RESPONSE TO COMMENTS

EPA received comments on the Cook Inlet Pipeline Company (CIPL), Drift River Terminal Permit, AK-00039-6 from Unocal - CIPL, the Cook Inlet Regional Citizens Advisory Council (RCAC) and Cook Inlet Keeper on behalf of the Alaska Center for the Environment, Alaska Community Action on Toxics, Kachemak Bay Conservation Society, the National Marine Wildlife & Habitat Committee of the Sierra Club and Trustees for Alaska. Dan R. Williamson of Anchorage, Alaska, and David L. Brimberry of Eagle River, Alaska, wrote letters in support of the permit reissuance.

BALLAST WATER TREATMENT SYSTEM

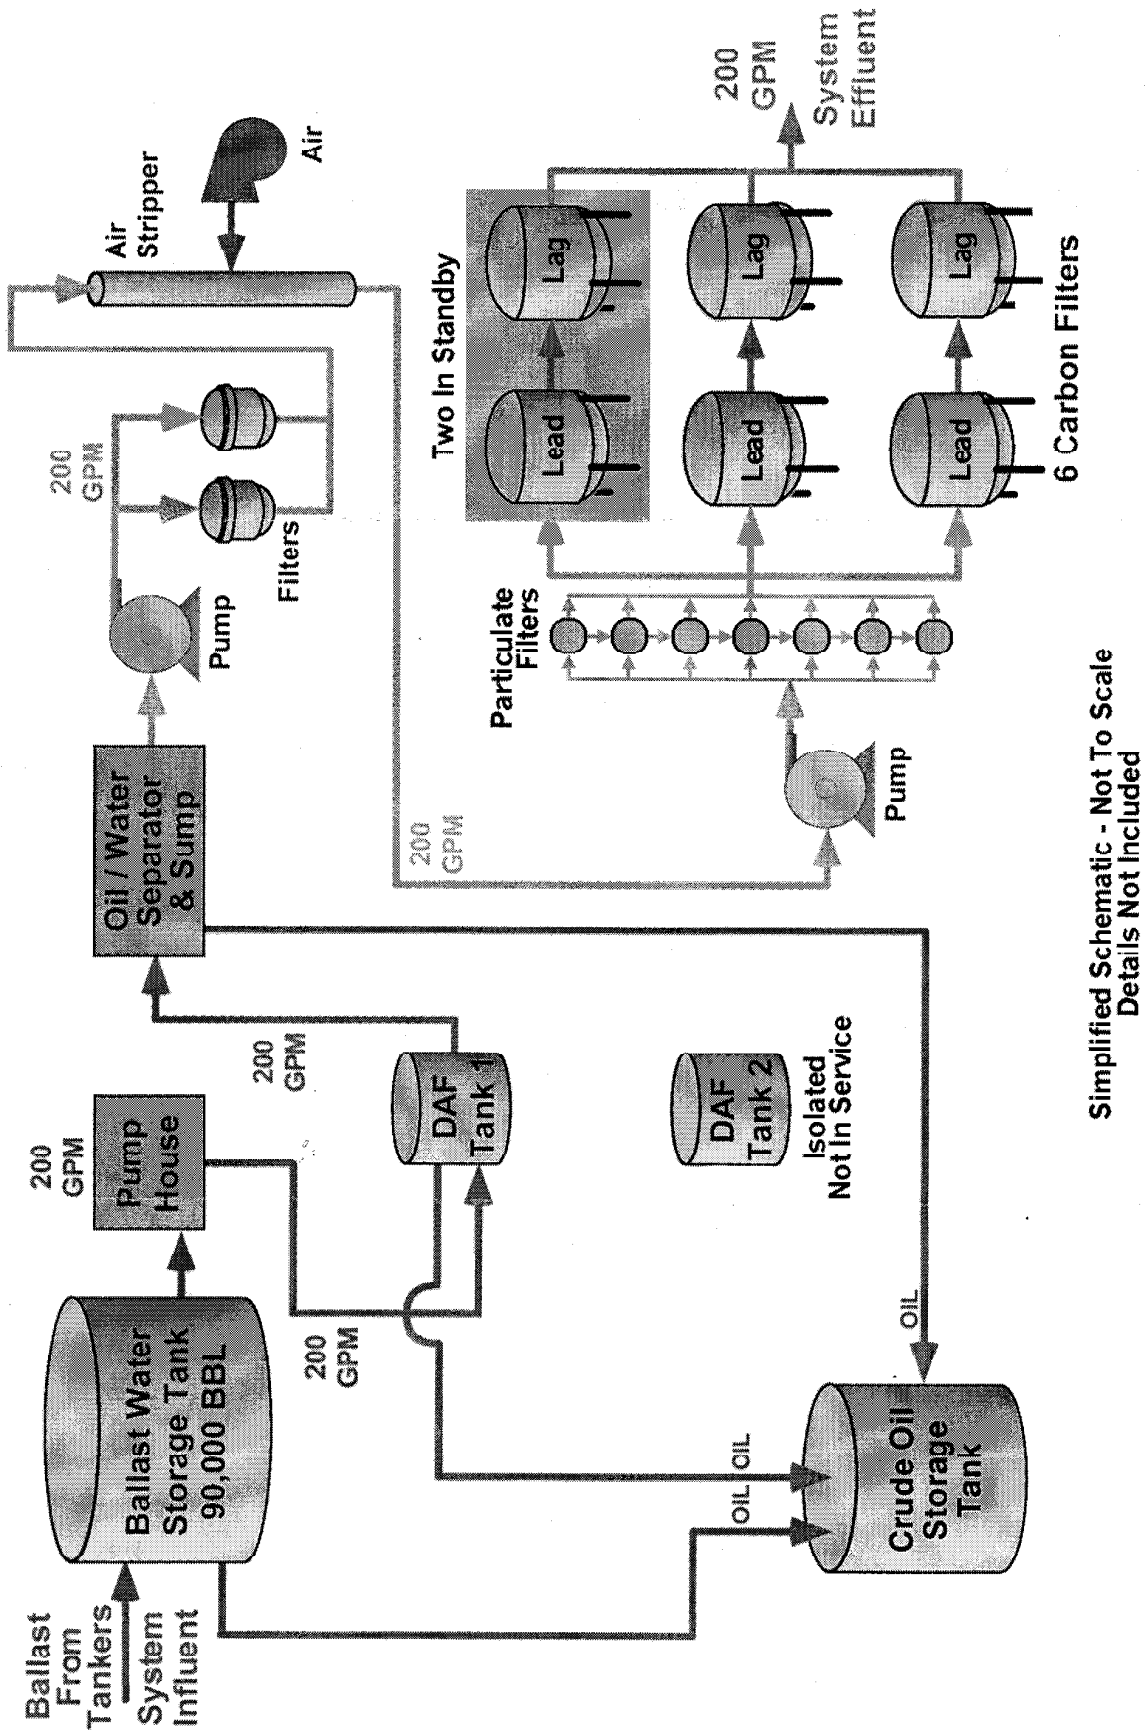
17. **Comment:** The Keeper comments that CIPL should have a total of 12 carbon filters so that two can be operating in series with the existing six shown in the schematic attached to the Fact Sheet.

38. **Comment:** RCAC notes that the schematic of the Drift River Terminal was incorrect in its illustration of the carbon filters.

Response: The flow diagram depicting this part of the treatment system was drawn as if the carbon filters were operating in parallel. This is not the case. The filters operate in a series of two filters with two on standby and two being maintained. According to CIPL, the filters are capable of handling the maximum system flow which is 200 gpm so it is not necessary to have all six filters operating simultaneously with an additional six in series. CIPL has provided a new schematic to show the actual operations, this is included in this Response to Comments as Attachment A.

Response: See response to Comment 17 and Attachment A of this Response to Comments.
